Jefferson Proving Ground Madison, Indiana

Draft Final Phase II Remedial Investigation

Re: Draft Final Remedial Investigation
Jefferson Proving Ground,
Madison, IN

Figure 13-15. Distribution of 1,1-Dichloroethene as of June 1996 Sampling Round at Building 602 Solvent Pit (Site 12A)

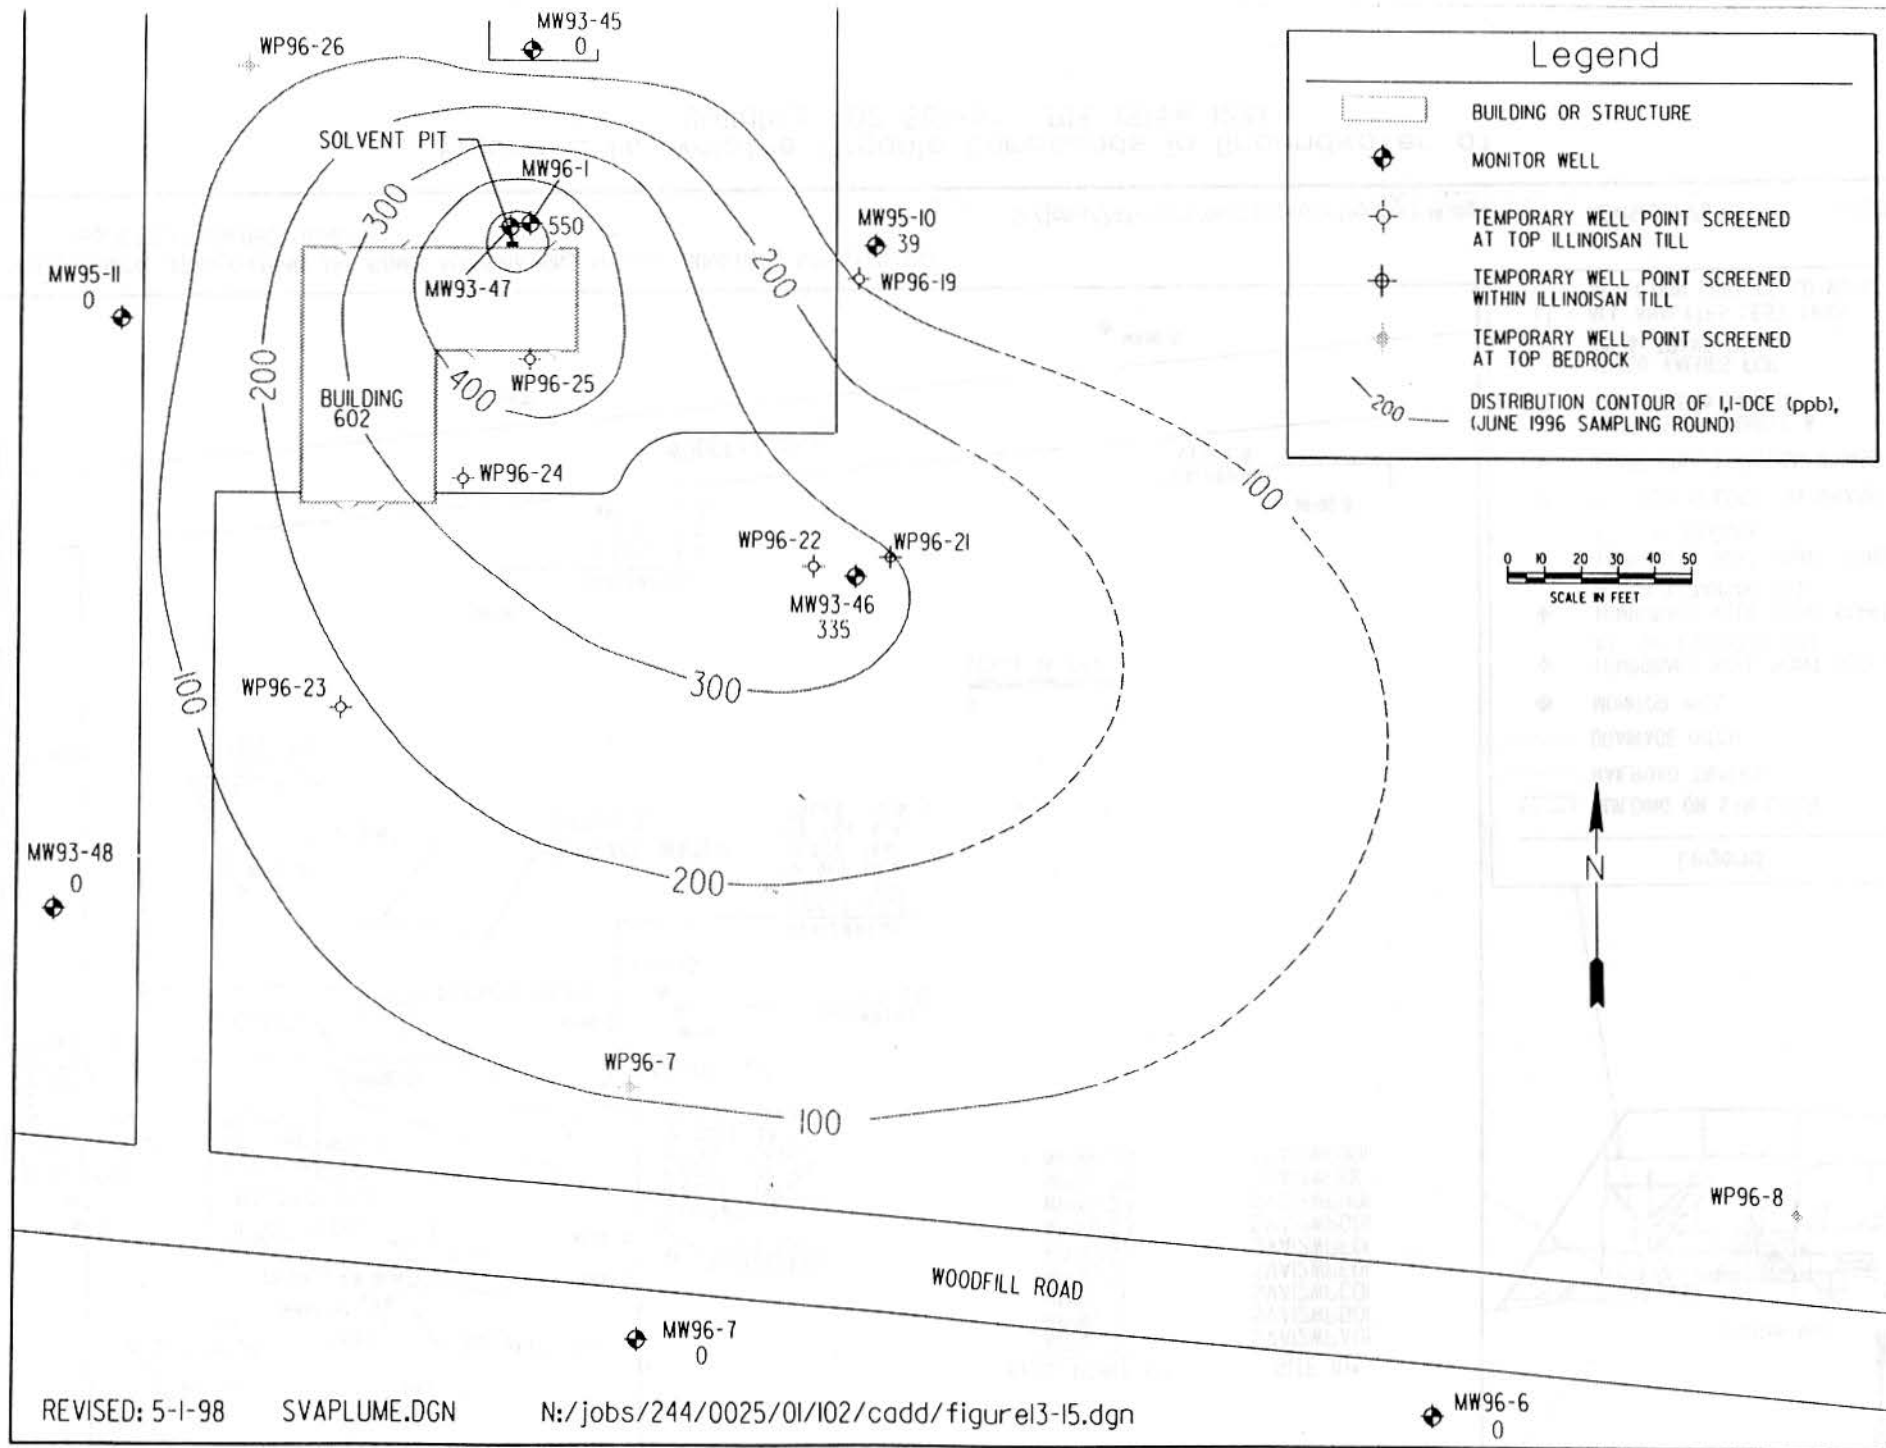
| Comment # | Section | EPA 31 May 2002 Comment | Army Response Submitted 21 June 2002 | EPA Evaluation of Response | Resolved (yes/no) |
|-----------|---------------|--|--|----------------------------|-------------------|
| EPA 12 | Sec 13.0 | <p>Building 602 solvent pit Site 12A; Section 13.1.1 Groundwater: Figures 13-7a, 13-7b, 13-15a do not show data for two of the three wells added in 2001 for the Data Gap Investigation (MW01-09 and MW01-11) The wells are essentially the same for Figures 13-5, 13-6, 13-7, 13-8, 13-9, 13-10 and figure 13-15. Why would one interpret the data on 13-7a and 13-7b any different than “normal” variation?</p> | <p>All new wells, including MW01-09 and MW01-11, are shown with data on Figure 13-15a. These wells were installed in November 2001. Figure 13-7a reflects the potentiometric surface from data collected before the wells were installed. Figure 13-7b reflects the potentiometric surface from data collected in November 2001. The new wells are shown on Figure 13-7b but were not used in the contouring because wells MW01-09 and MW01-10 were screened in a deeper bedrock unit, and MW01-11 was not static at the time of sampling.</p> | | |

FIGURE 14-10a

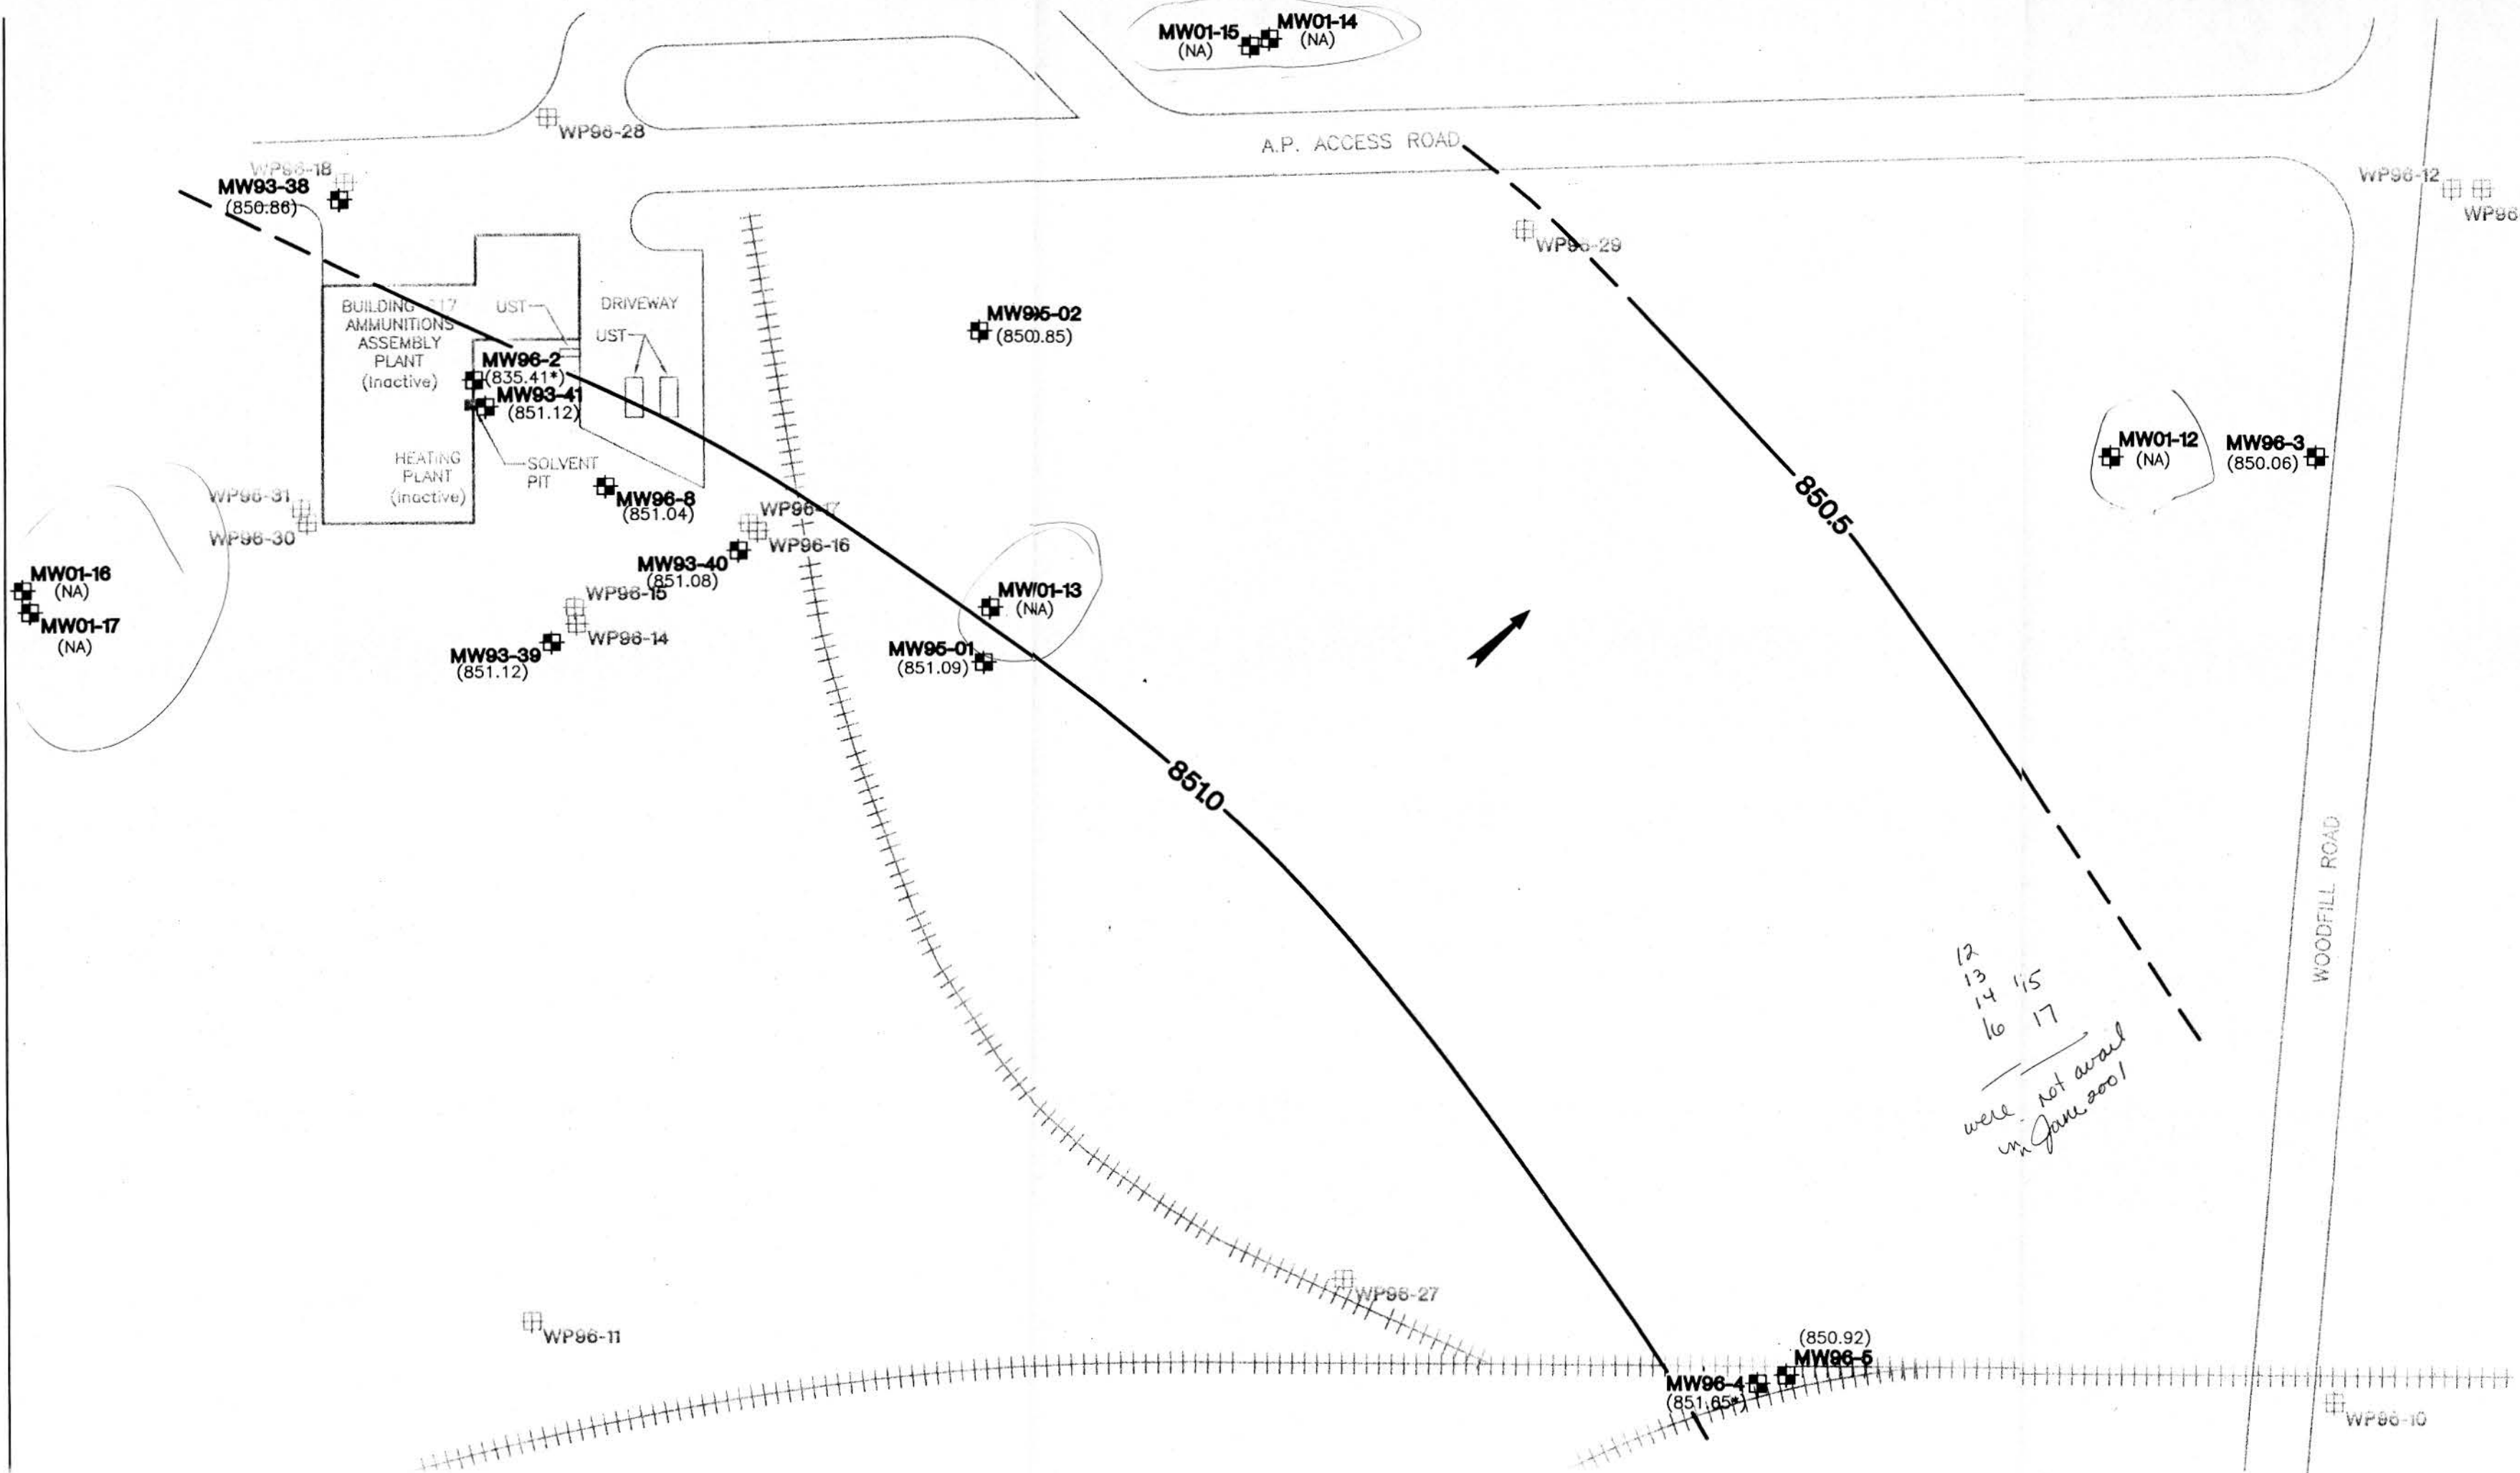
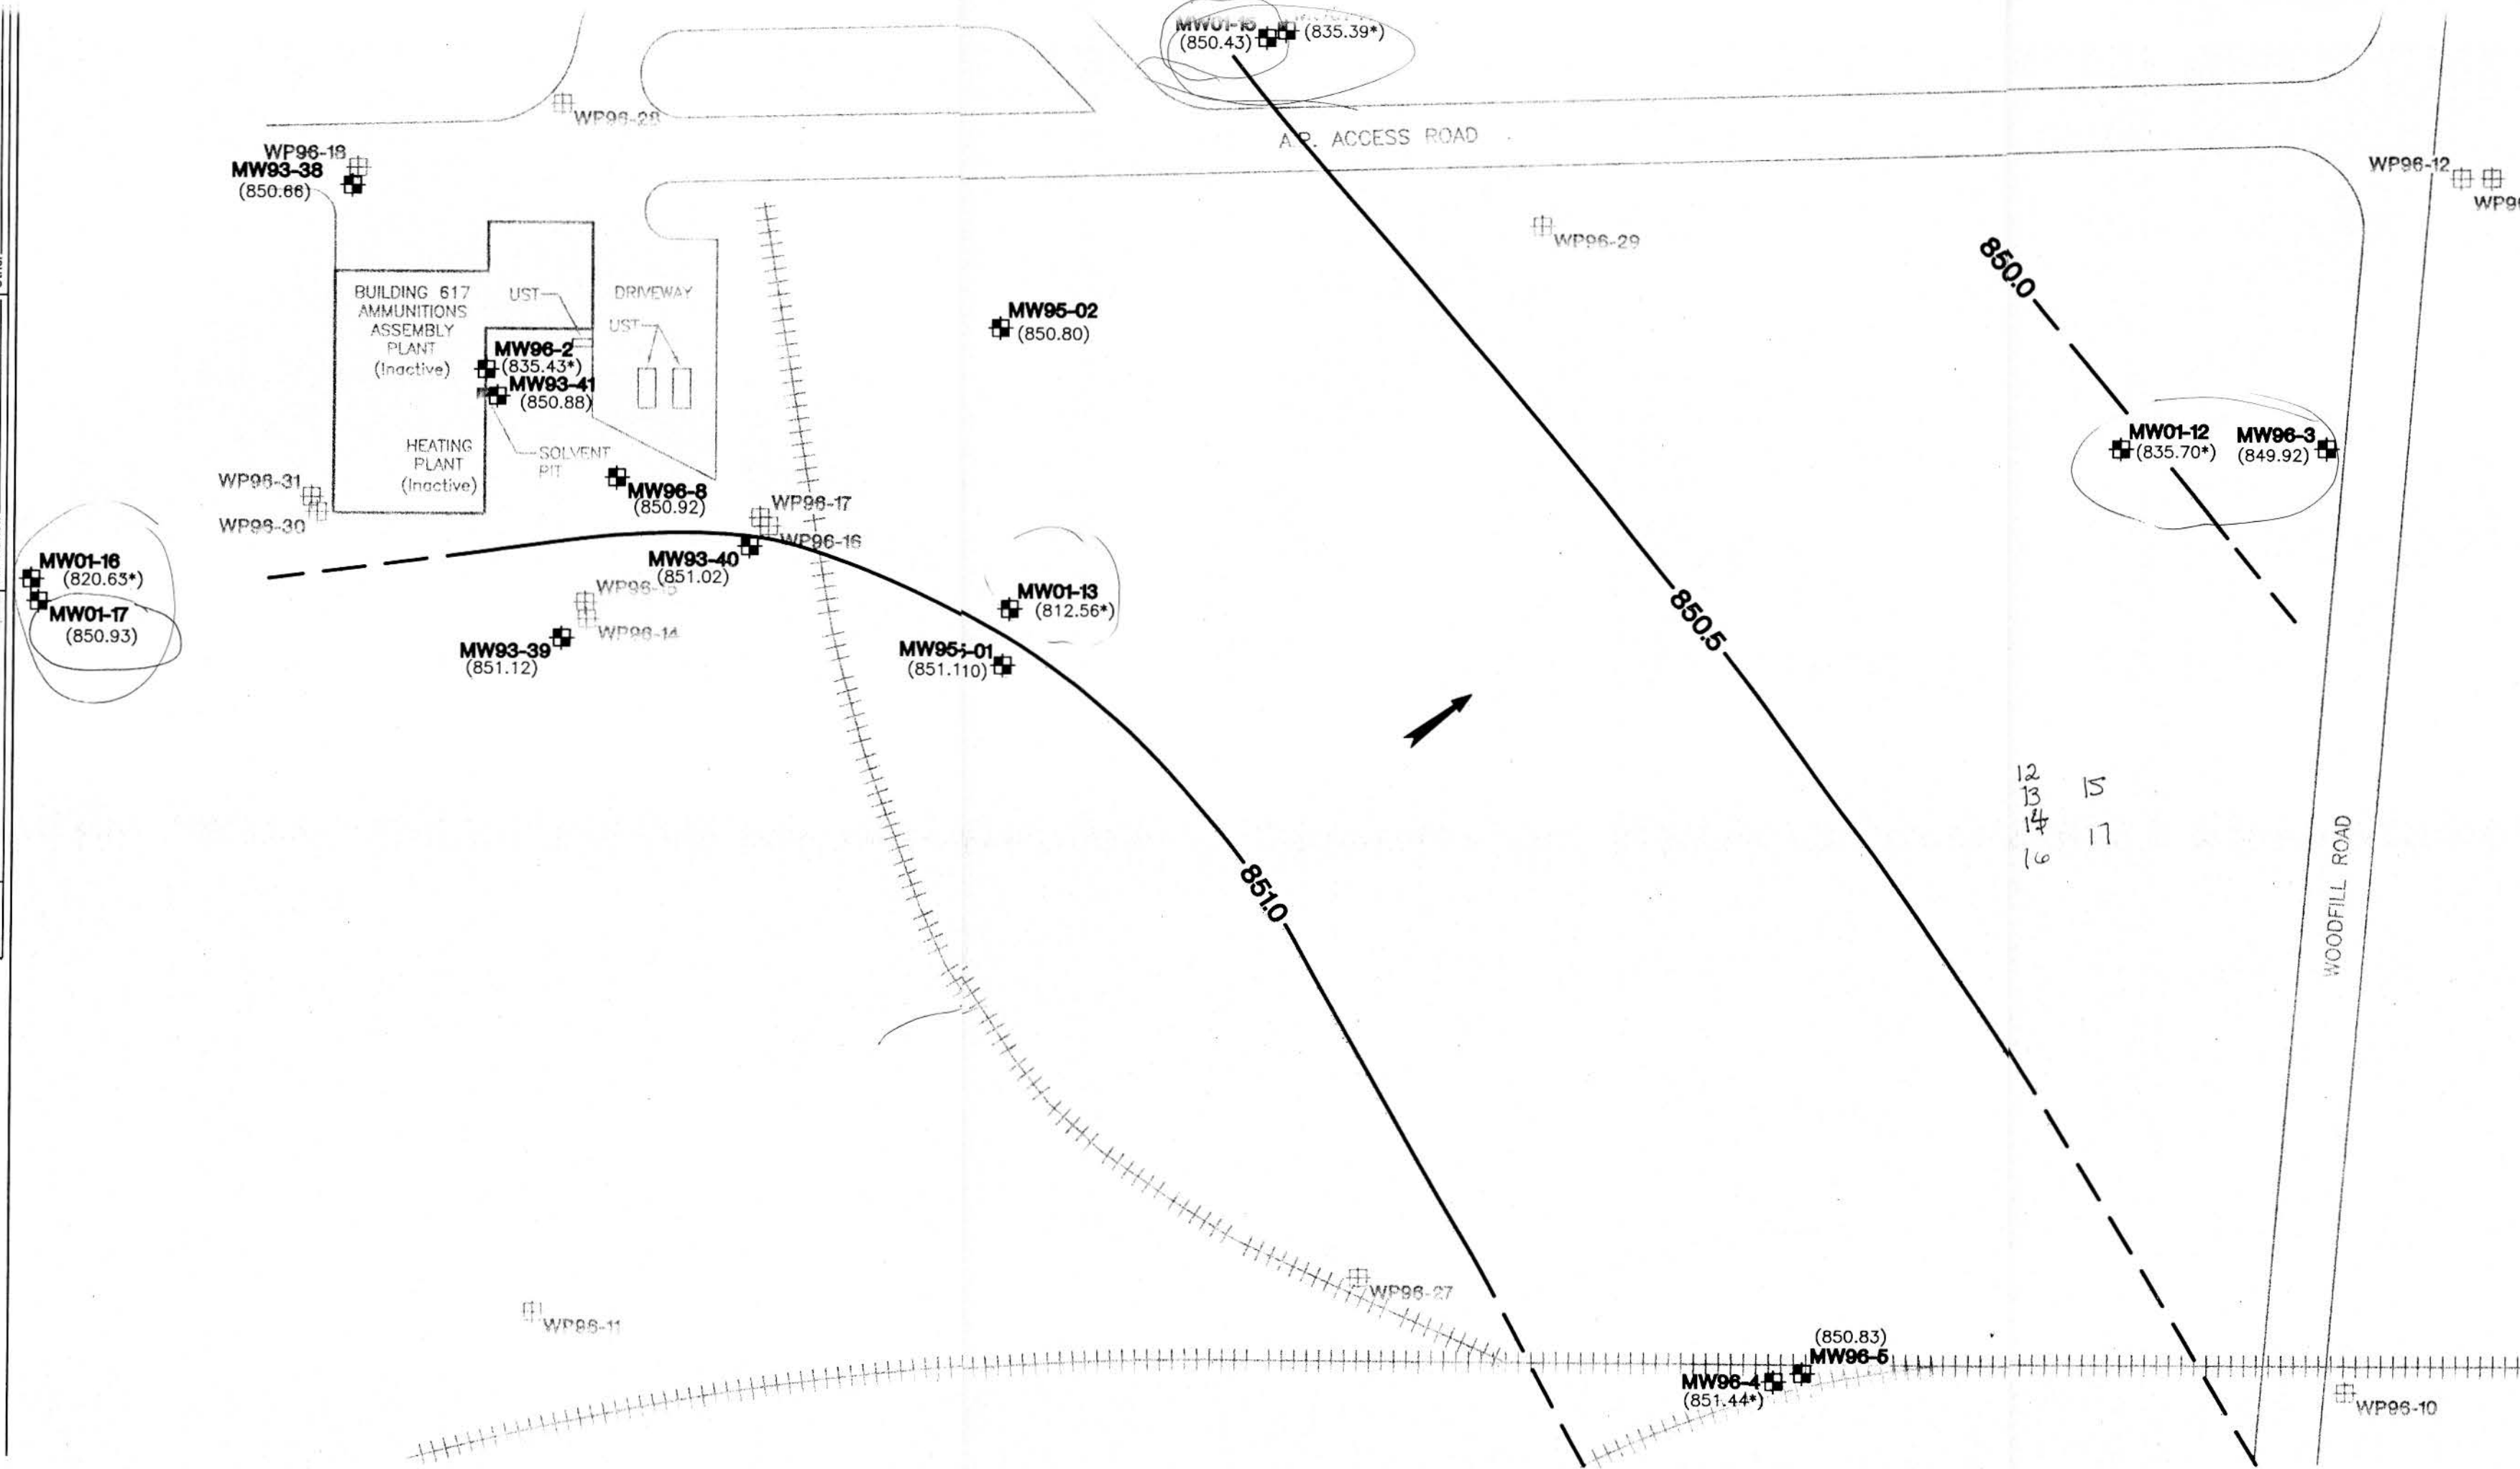
| Comment # | Section | EPA 31 May 2002 Comment | Army Response Submitted 21 June 2002 | EPA Evaluation of Response | Resolved (yes/no) |
|-----------|--------------|---|---|----------------------------|-------------------|
| EPA 14 | Sec 14.0 | <p>Building 617 Solvent Pit (Site 12B): Due to the availability of all well data, the November 2001, Figure 14-10b is more current than the June 2001, figure 14-10a. It is noted that in the November 2001, Figure 14-10b, the only well that has been added to this figure is MW01-13 when comparing this figure with November, 1996. The groundwater flow is only 90 degrees off. With the variation seen earlier, can it be stated that the November 2001 is any better than the 1996 figure, with the addition of only one well? It appears that the November 2001 Figure is highly biased in over all conclusion of the groundwater flow direction. There has been little addition of data from 1996.</p> | <p>Six wells were added during November 2001, MW01-12 through MW01-17. All of these wells appear on Figure 14-10b, which represents the November data. However only 2 wells (MW01-15 and 01-17) are used in the contouring of the potentiometric surface on this Figure. The other four wells were not used because they are screened in a deeper bedrock unit.</p> | | |
